Service Bulletin

iR5570
iR6570

iR6570-015
(F1-T01-0M5-10041-01)

The information about a SNMP setup is added to the Service Manual

F-1

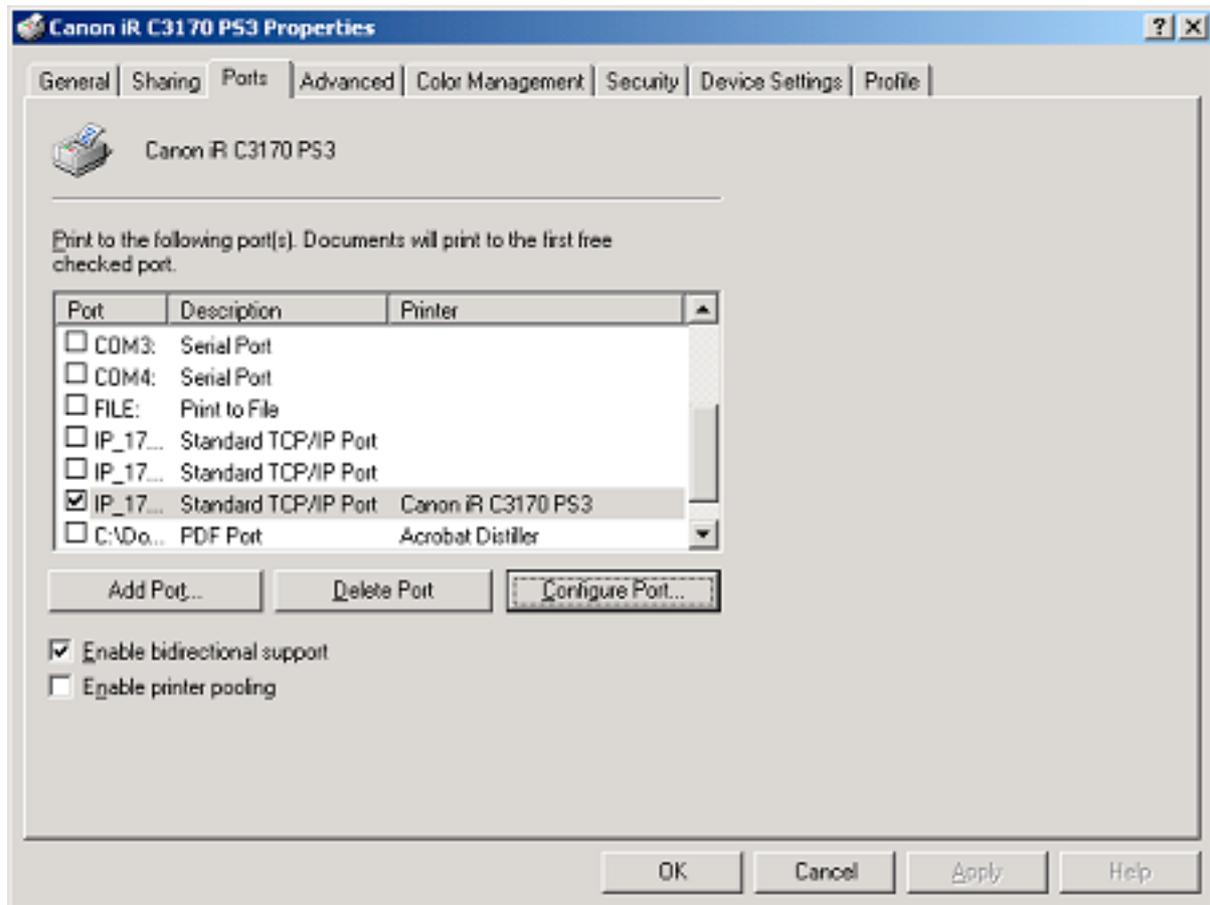
When the machine is used as a Windows printer, enabling 'Use SNMP' causes the operating system to collect machine status information at specific intervals, preventing the machine from starting a sleep state.

To avoid the situation, disable the setting (Windows' printer properties).

1) Select 'Configure Port' on the Ports screen (printer properties).
